BEFORE THE PUBLIC UTILITIES COMMISSION OF OHIO

In the Matter of the Authorization of
Norfolk Southern Railway To Install
Active Warning Devices at a Grade
Crossing in Fulton County.

: Case No. 16-1413-RR-FED

: **REQUEST FOR VARIANCE, AND**
TO EXTEND PROJECT DEADLINE

NS NORFOLK SOUTHERN
 OFFICE OF ASS'T. VICE PRESIDENT
 COMM. & SIGNAL, ATLANTA, GA.
 M.P.: CD-328.26
 ARCHOLD, OH
 FLGS AT W. BARRE RD.
 CHICAGO LINE
 FILE NO. R-
 SHEET 1 of 22
 CADD OF DWG. No. 35003283.01

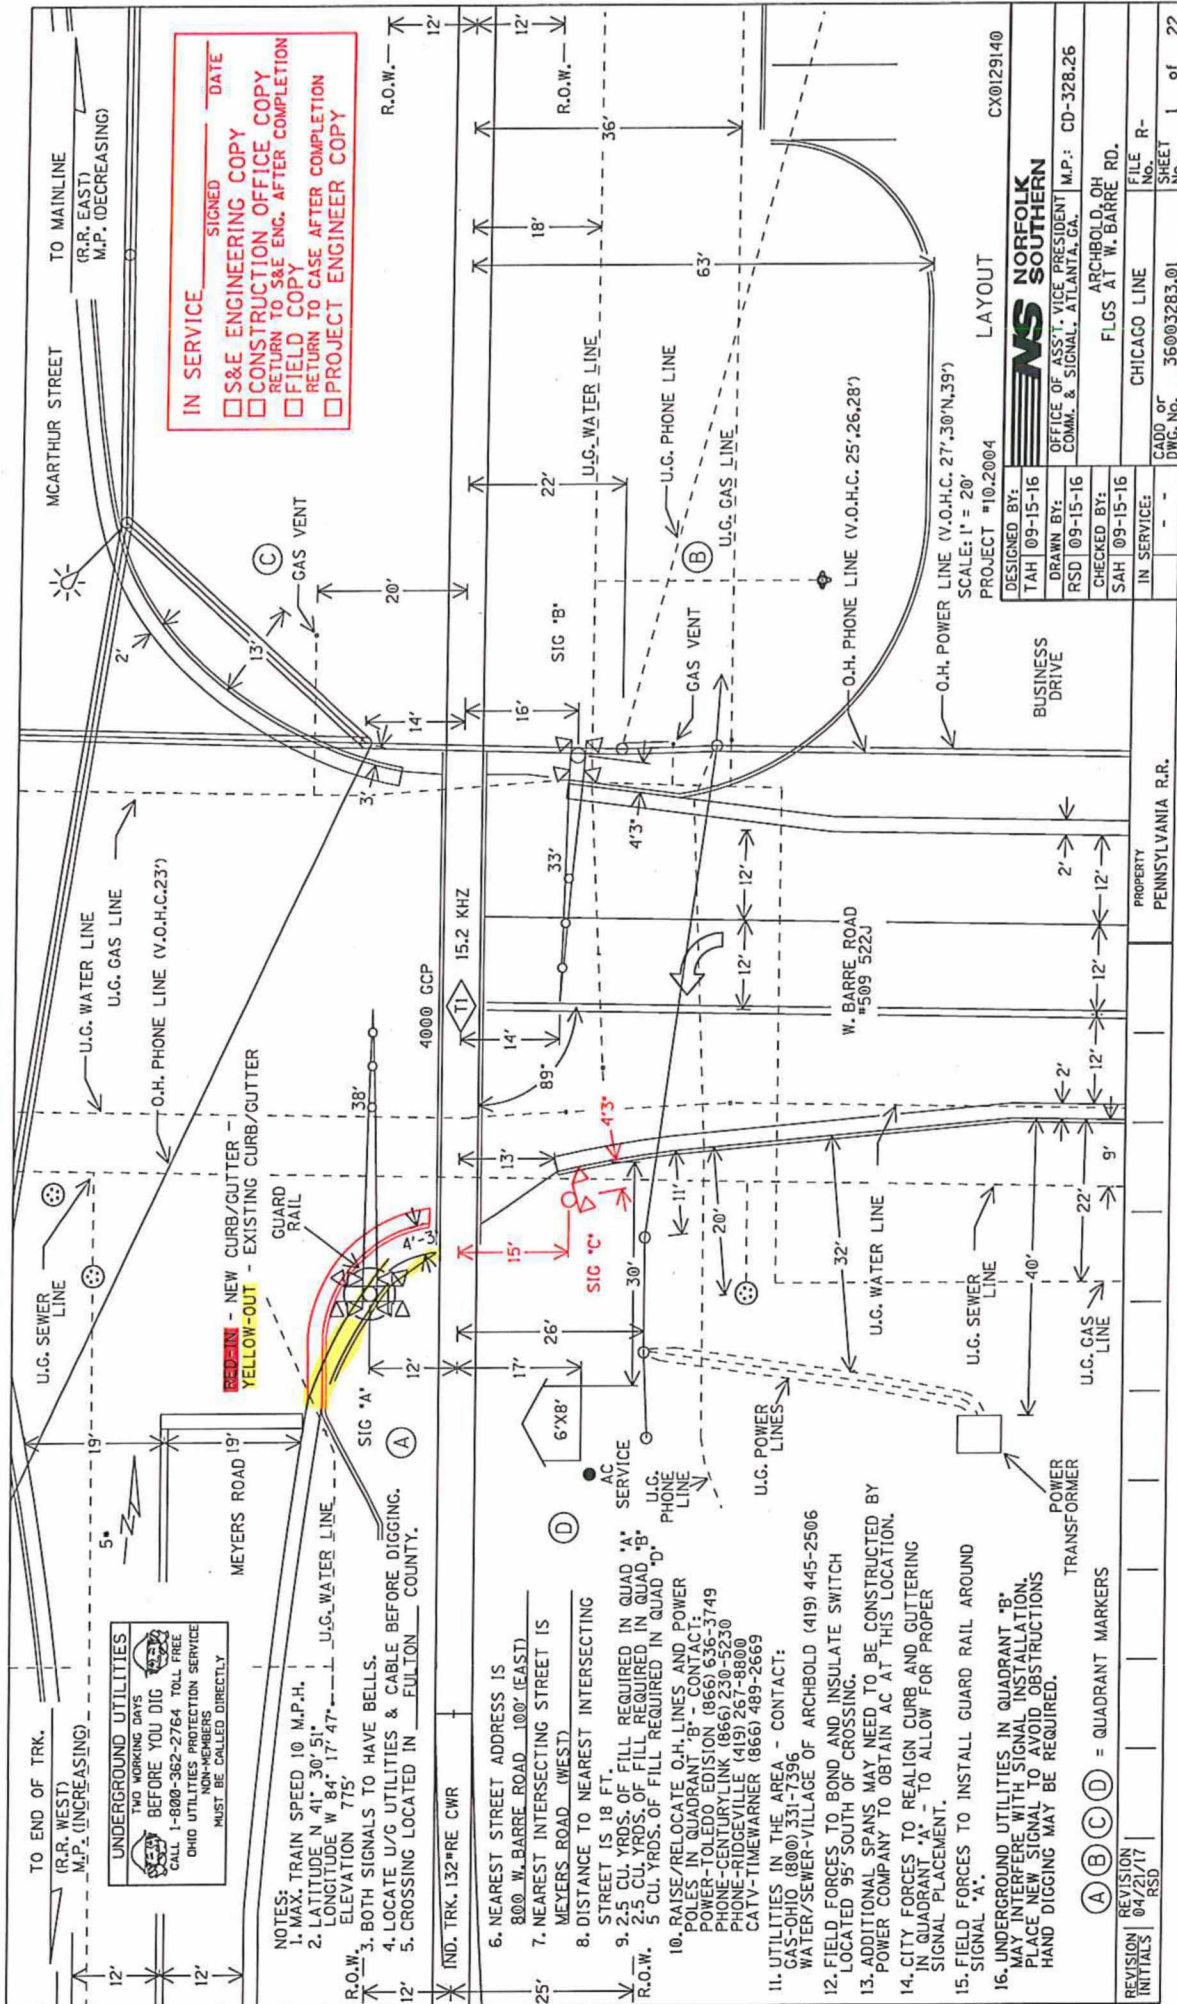
This was a complex project, from its inception, which required construction in three of the four quadrants of the crossing. Construction in two of the three quadrants is largely completed. Concerns have risen, however, with respect to the cantilever which was to have been placed in the third involved quadrant, the northeast, with its lights to direct the westbound left turn lane of West Barre Street. Specifically, additional utility conflicts have arisen, since the project's authorization, which appear unresolvable. These conflicts appear to preclude the intended placement of the cantilever foundation; accordingly, NSRC respectfully requests the Commission's authority to vary from its original Finding and Order – specifically, in lieu of the cantilever installation, NSRC seeks authority to install flashing lights in the southeast quadrant, thereby directing the same westbound left turn lane. (See proposed re-design, attached.) Due to the

Additional Left-Hand Flashing Light Assembly: As part of the application for the variance, the proposed site layout would be revised to include a flashing light assembly to be installed on the left side, in the southeast quadrant D. This should add another set of lights for the west-bound moves in the left-turn lane on W. Barre Rd.
